MARKED-UP DRAWING (NOT TO SCALE)

client	MRS S FADRE
project	1 - 8 COLLEGE YARD LONDON TMS
drawing	MARKED-UP SITE PLAN
date	June 08
scale	NTS
drawn by	st
checked by	rev
ENX SK-030

ENX. SK-030

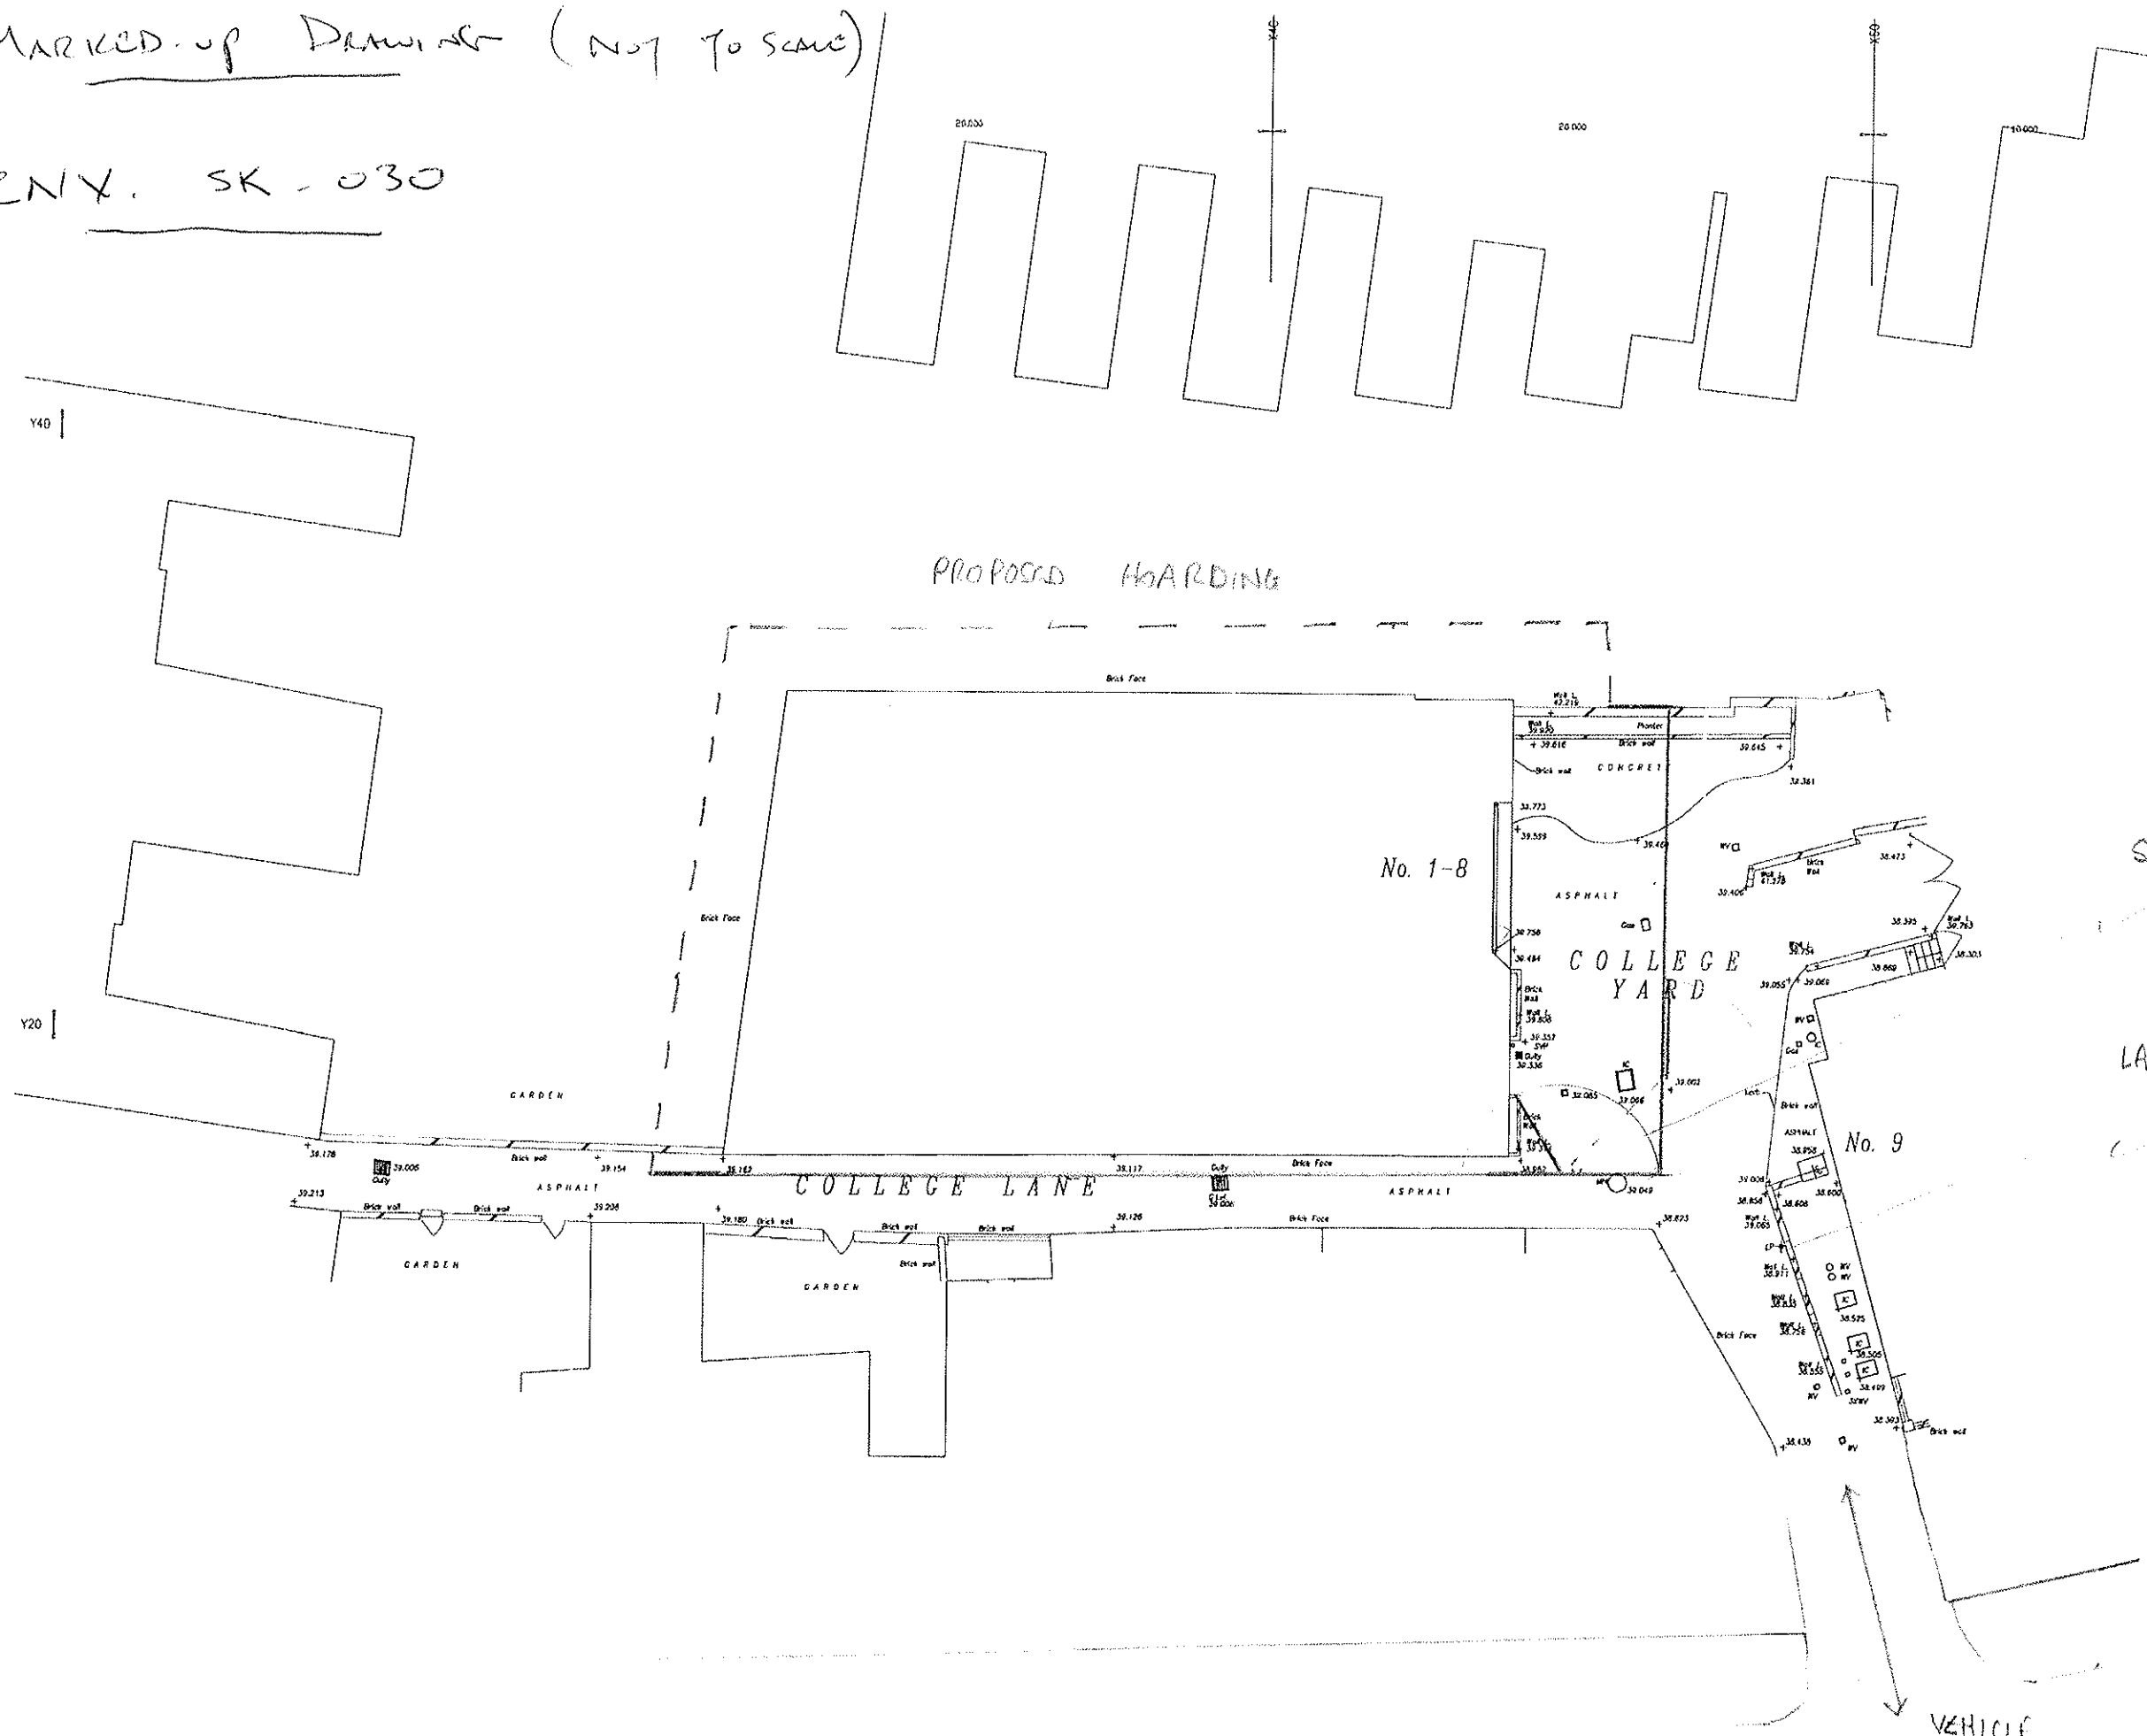
SITE ENTRANCE GATES

LAMP POST RE-POSITIONED
